# DEVELOPMENT REVIEW COMMITTEE (DRC) COMMENT REPORT

MEETING DATE:	May 23, 2023
Property owner / Applicant:	Spectrum Management, LLC.
AGENT:	Andrew Schein, Lochrie & Chakas, P.A.
PROJECT NAME:	The Austin
CASE NUMBER:	UDP-S23024
REQUEST:	Site Plan Level II Review: Mixed Use Development Consisting of 81 Multifamily Residential Units and 7,054 Square-Feet of Commercial Use with Associated Parking Reduction in the Northwest Regional Activity Center
LOCATION:	1201-1205 NW 6th Street, 1210 NW 6th Court and 619 NW 12th Avenue
ZONING:	Residential Multifamily Mid Rise/ Medium High Density (RMM-25) and Northwest Regional Activity Center- Mixed Use west (NWRAC-MUw)
LAND USE:	Northwest Regional Activity Center
CASE PLANNER:	Nick Kalargyros

Principles of Building Design Standards

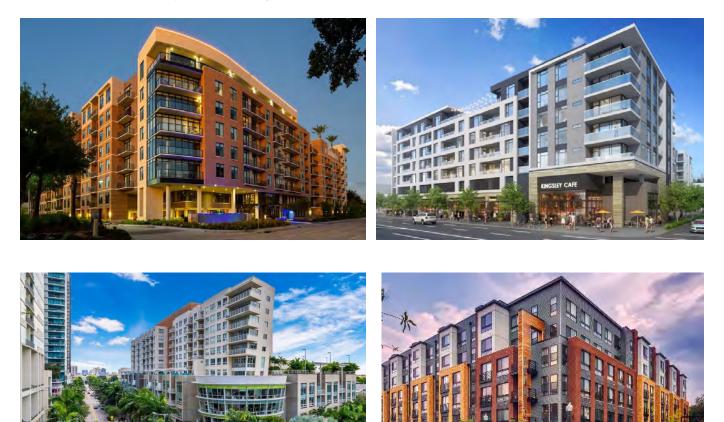
- 22. The project does not meet certain Northwest Master Plan design intents as outlined in ULDR, Section 47-13.29 and Section 47-13.31, respectively. Staff has commented below under the applicable category and has provided images to assist the applicant.

- a. B-8, building exceeds the maximum streetwall length of 150-feet and project must provide a variation in the physical design and articulation of the streetwall. The east and west elevations (currently 252 feet) need to address this requirement. Ensure that the treatment and articulation along elevations provide an attractive and pedestrian-friendly environment along its length.

- b. B-9d, required first floor height is a minimum of 15 feet. Update the elevations along each façade to show the first floor height at 15 feet.
- c. B-11, residential transition zone with a minimum yard setback of 15 feet and maximum shoulder height of 45 feet and minimum tower stepback of 15 feet needs to be provided on elevation sheets.

- f. B-15, expand the use of high-quality material, especially to accentuate the corners.
- g. B-16, provide double-story height at the corners for better pedestrian visual interest.

- h. B-17, provide creative façade composition with layering of architectural elements that are provided throughout the building with an original design having a strong identity and high-quality expression of the architectural style.
